Access Compliance Report

Public Rights-of-Way

Intersection ID: 10025333	Main Street: E_6TH_ST	Cross Street: N/A	Location: S
ADA ID: 11B29FCB9B19	Ramp Type: Perp	Initial Pass/Fail: Pass	Overall Compliance: No
Severity Score: 0			
Codes/Mitigation Info/Possible Solution		Field Measurements/Component Compliance

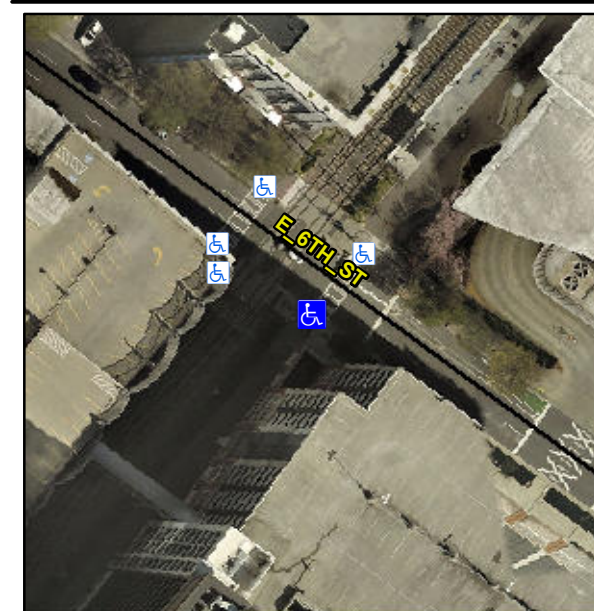
Not Found, R304.2.2-Perp, R304.3.2-Para

Compliance	Description	Data	Compliance	Description	Data
N/A	Ramp Length (in)	38.0	Yes	Ramp Slope (%)	5.5
Yes	Ramp Width (in)	48.0	Yes	Ramp XSlope (%)	0.3
N/A	Flare Type LT	Sloped	N/A	Flare Type RT	N/A
N/A	Flare Slope LT (%)	2.5	Yes	Flare Slope RT (%)	3.4
N/A	Flare Traversable LT?	Yes	N/A	Flare Traversable RT?	Yes
Yes	Landing Length (in)	48.0	Yes	DWS Provided?	Yes
Yes	Landing Width (in)	48.0	Yes	DWS Contrast?	Yes
No	Landing Slope (%)	4.5	Yes	DWS Length (in)	24.0
Yes	Landing X Slope (%)	0.4	Yes	DWS Full Width?	Yes
N/A	Landing Curb? (Y/N)	No	Yes	DWS Offset (in)	1.5
N/A	Shared Landing?	No			
Yes	Gutter Ponding?	No	Yes	Gutter Slope (%)	2.4
Yes	Gutter Lip Ht (in)	0.0	Yes	Gutter X Slope (%)	1.3
N/A	Painted X Walk1?	Yes	N/A	Painted X Walk2?	N/A
	X Walk 1 Direction	To NE		X Walk 2 Direction	N/A
N/A	X Walk 1 Width (in)	109.0	N/A	X Walk 2 Width (in)	N/A
	X Walk 1 Slope (%)	1.8		X Walk 2 Slope (%)	N/A
	X Walk 1 X Slope (%)	0.5		X Walk 2 X Slope (%)	N/A

Yes	Ramp inside XWalk1?	Yes	N/A	Ramp inside XWalk2?	N/A
	Road Slope (%)	N/A	N/A	Clear Space?	Yes
	Road X Slope (%)	N/A	N/A	Clear Space to XWalk (in)	N/A
Yes	Any Obstructions?	No	Yes	Storm Grate/Utility Hazard?	No
	Obstruction Type			Storm Grate/Utility Type	
		N/A			N/A
			Yes	Surface Condition? (G/P)	Good

Remove & Replace Entire Ramp.
